April 29, 2021

Reference: Uniform Construction Code (UCC)
2018 International Codes Adoption

Figure R311.7.4
WINDER TREAD AND LANDING DETAIL

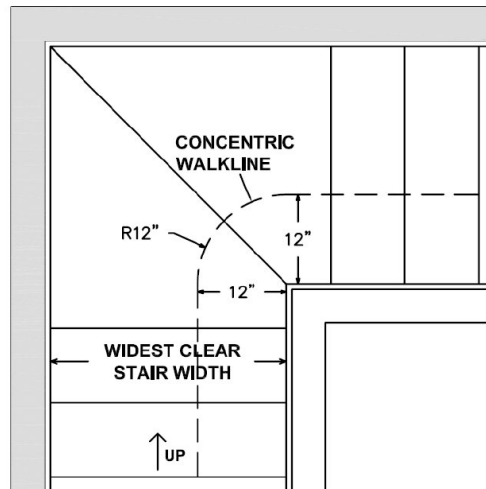
- Section R311.7.4 Walkline, is adopted as follows:

R311.7.4 Walkline. The walkline across winder treads and landings shall be concentric to the turn and parallel to the direction of travel entering and exiting the turn. The walkline shall be located 12 inches (305 mm) from the inside of the turn. The 12-inch (305 mm) dimension shall be measured from the widest point of the clear stair width at the walking surface. Where winders are adjacent within a flight, the point of the widest clear stair width of the adjacent winders shall be used.
